From: (b) (6)
Sent: Sunday, July 31, 2022 9:30 PM
To: DC-Metro-CSR-Study
Cc: (b) (6)
Subject: [Non-DoD Source] Metropolitan Washington District of Columbia Coastal Storm Risk Management Feasibility Study

I am a home owner and resident of the New Alexandria (Belle Haven) neighborhood and am responding to the request for comments from the June 16, 2022 virtual meeting related to the NOVA Coastal Study by the USACE and the posted draft Integrated Feasibility Report and Environmental Assessment.

On behalf of our members in Virginia, the undersigned environmental and conservation organizations respectfully submit the following comments in response to the U.S. Army Corps of Engineers' (Corps) Draft Integrated Feasibility Report / Environmental Assessment for the Metropolitan Washington, District of Columbia Coastal Storm Risk Management (CSRМ) Study. The purpose of this CSRМ study is to evaluate solutions to reduce long-term coastal flood risk to vulnerable populations, properties, infrastructure, and environmental and cultural resources, while considering future climate and sea level change scenarios to support resilient communities in Northern Virginia within the Middle Potomac River

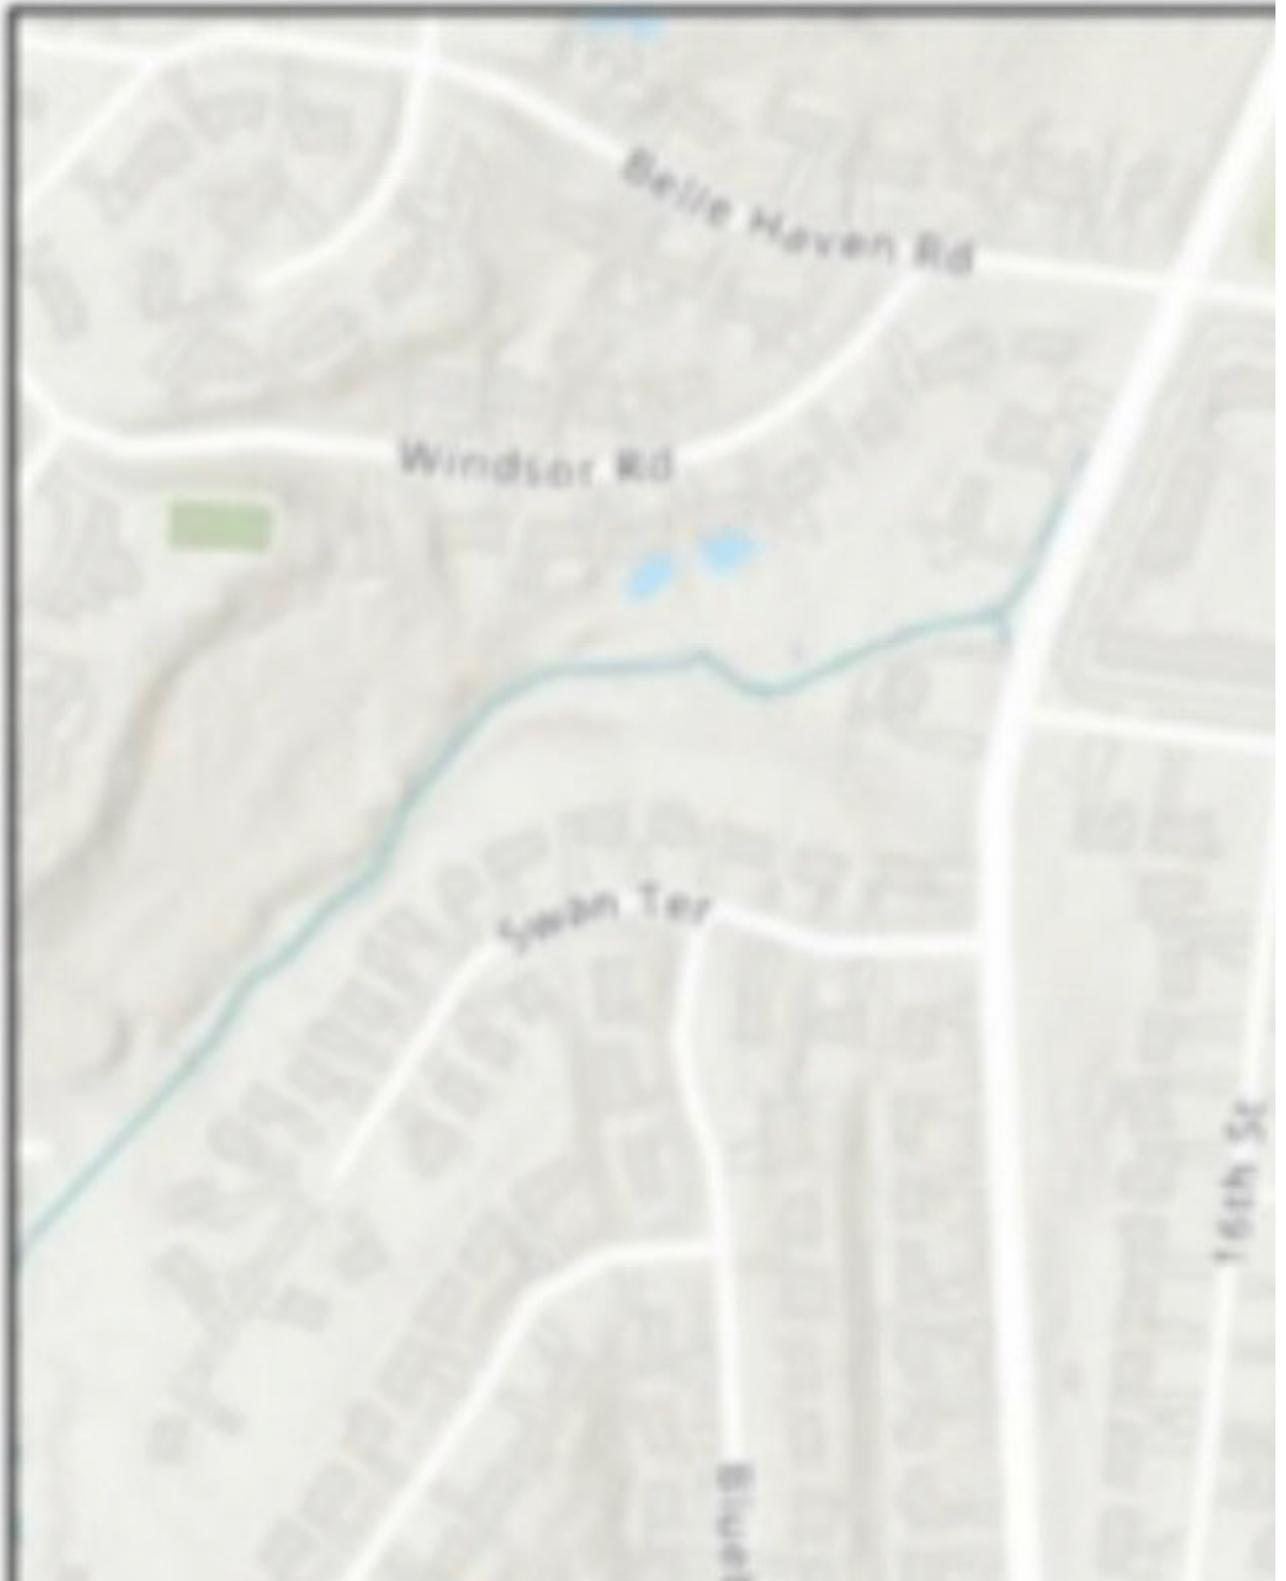
The plan as shown in FIGURE 2. TENTATIVELY SELECTED PLAN - BELLE HAVEN FLOODWALL AND LEVEE, appears to place the wall along the sidewalk at the rear of building 6621 and 6631, dividing River Towers' open spaces and severing its recreational assets, garden beds, tennis courts, lawns, community garden, and basket ball court from the rest of the property.

I have considered that to some residents on upper south facing units, locating the floodwall at the base of the building may provide a preferred uninterrupted green view of the marsh. However, the cost of that uninterrupted view for the few, is the elimination of any view for others.

-the severing of five (5) recreational assets

- dramatic division of our open parklike spaces
- installation of two ugly storm gates at the East lot that will be visible from the front of the building
- loss of landscaping and gardens near construction sites
- loss of mature trees near the buildings
- risk to two building foundations
- inconvenience navigating construction site and equipment to access homes during 2-3 year installation, especially for our elderly, handicapped, and young families
- devastating property values of more than 500 home owners
